ADDENDUM NO. 1

Date: October 11, 2024

Project: DPW PROJECT NO. 25110 – **Design Professional RFQ**

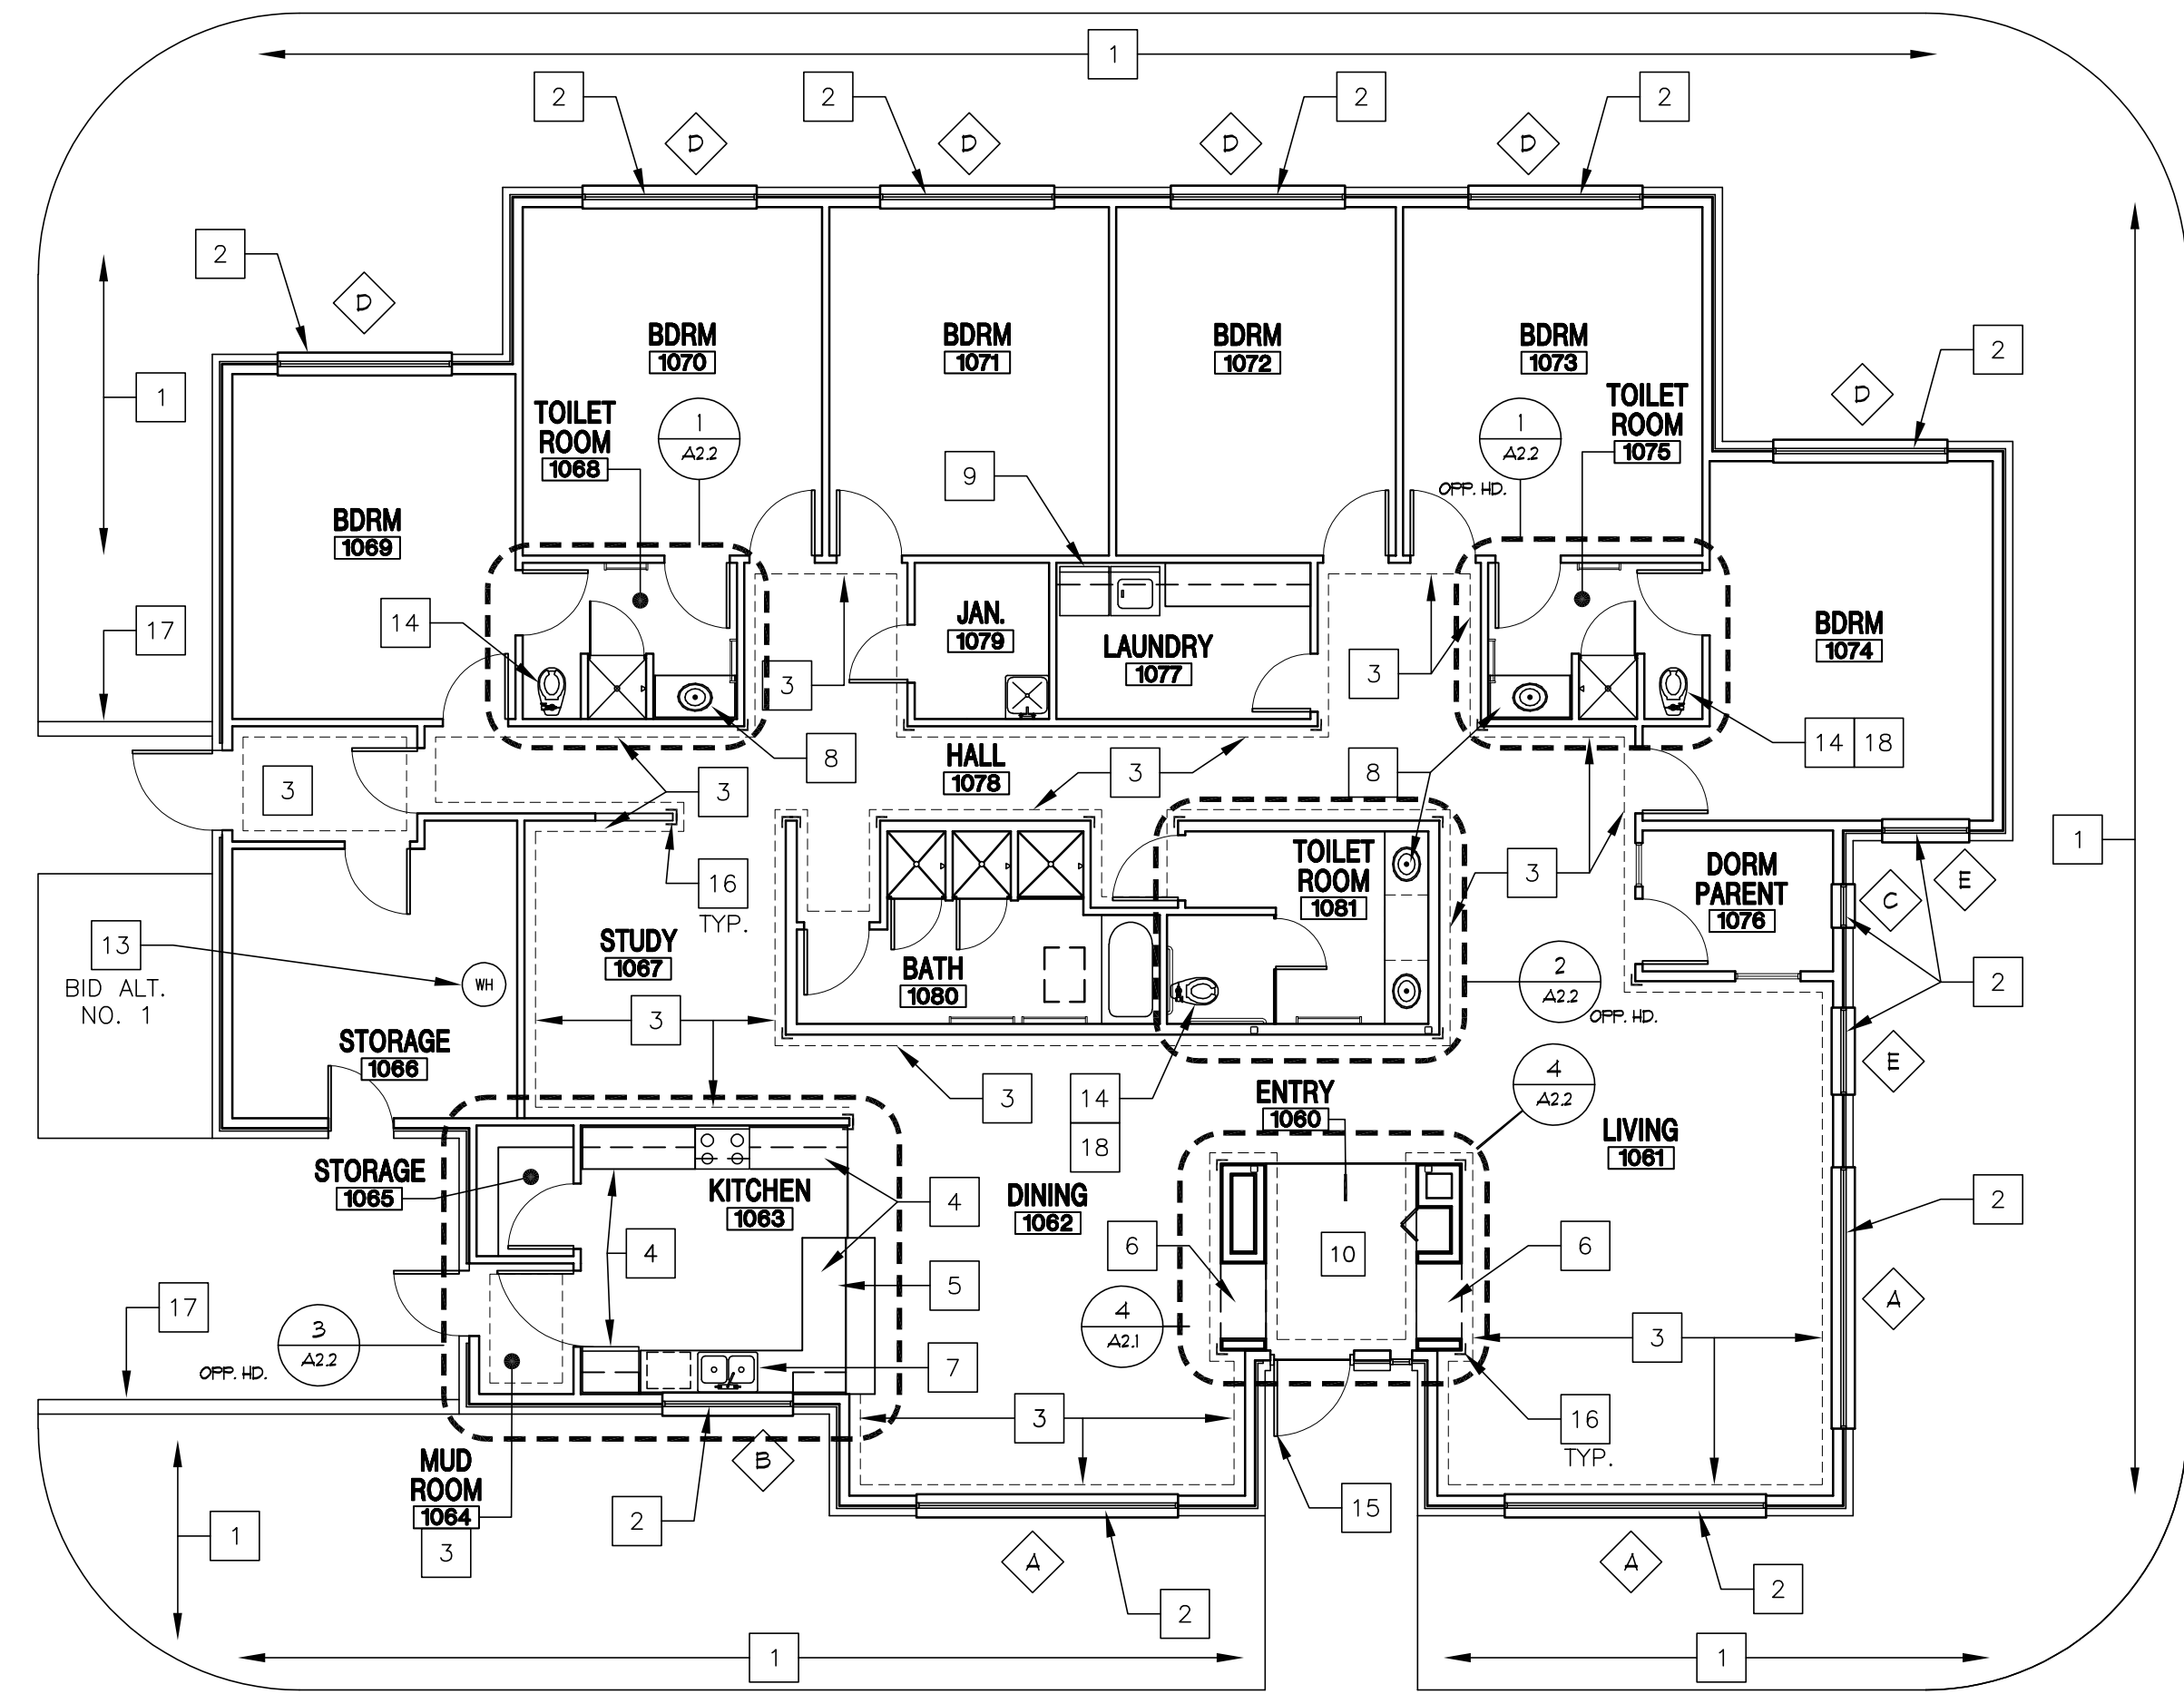
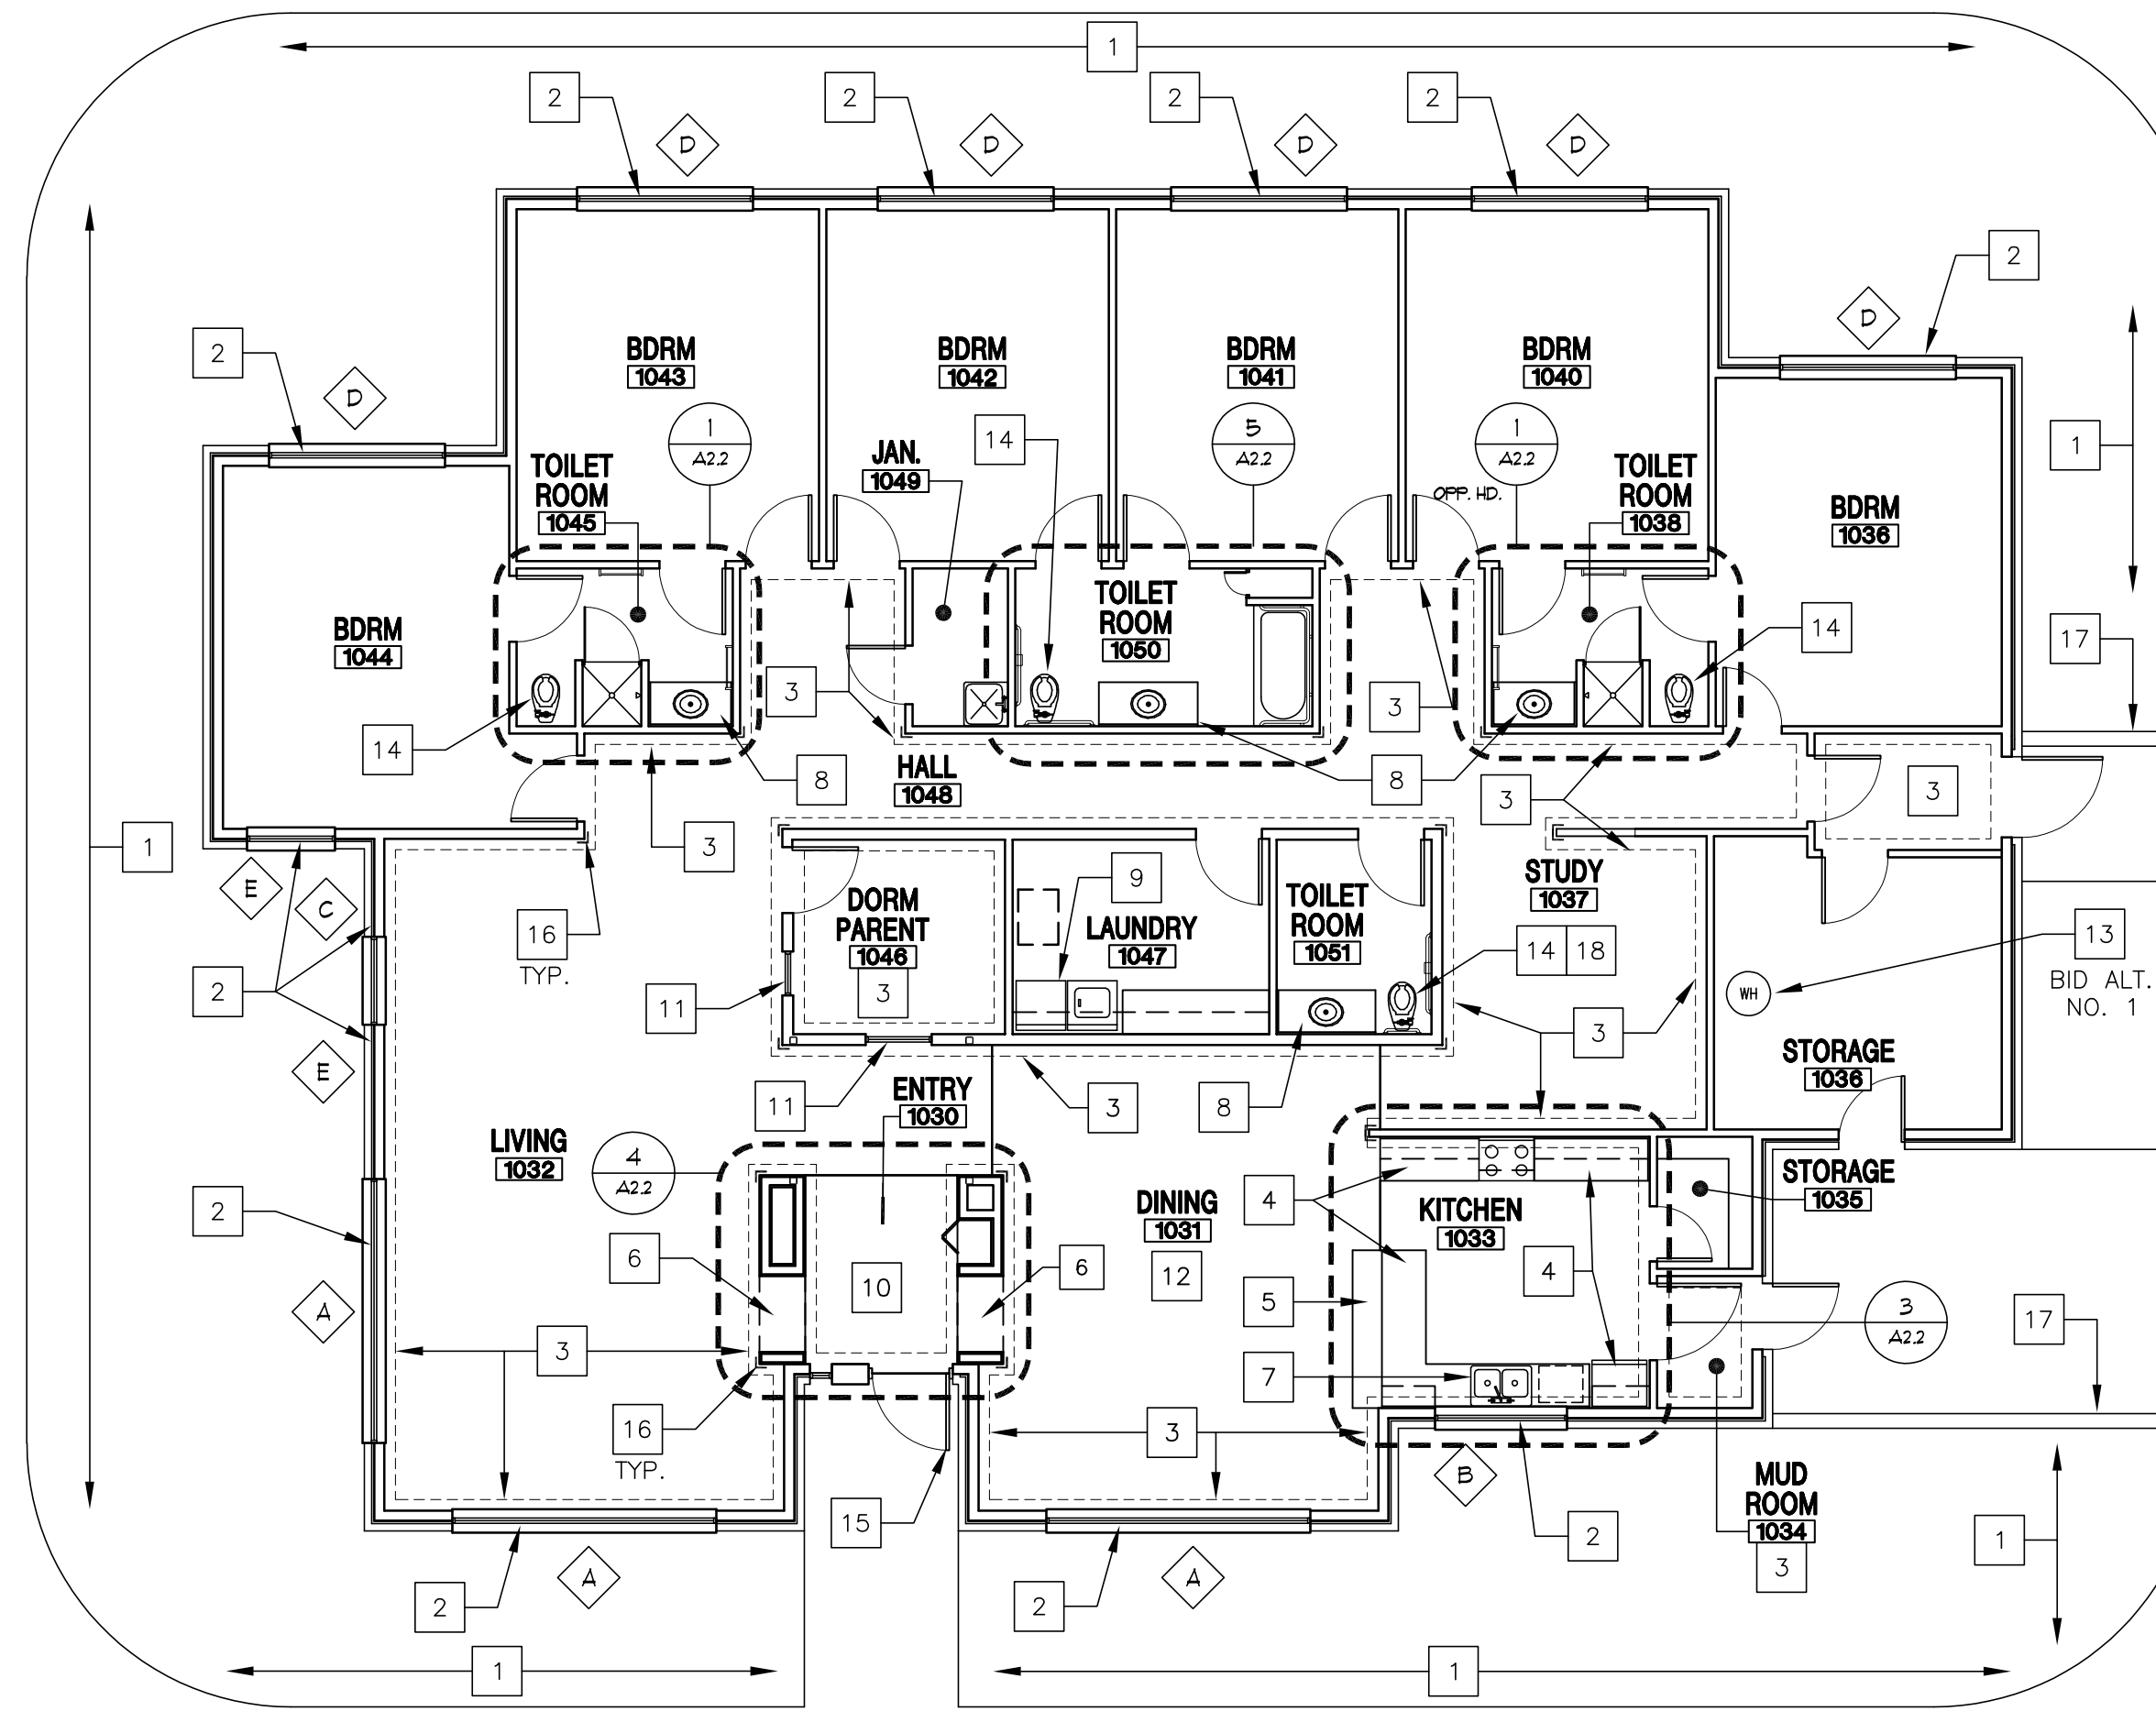
Question #1: Are existing drawings of the other cottages available to be shared?

Answer #1: Yes. See attached.

The new cottages are not anticipated to match the existing floor plans.
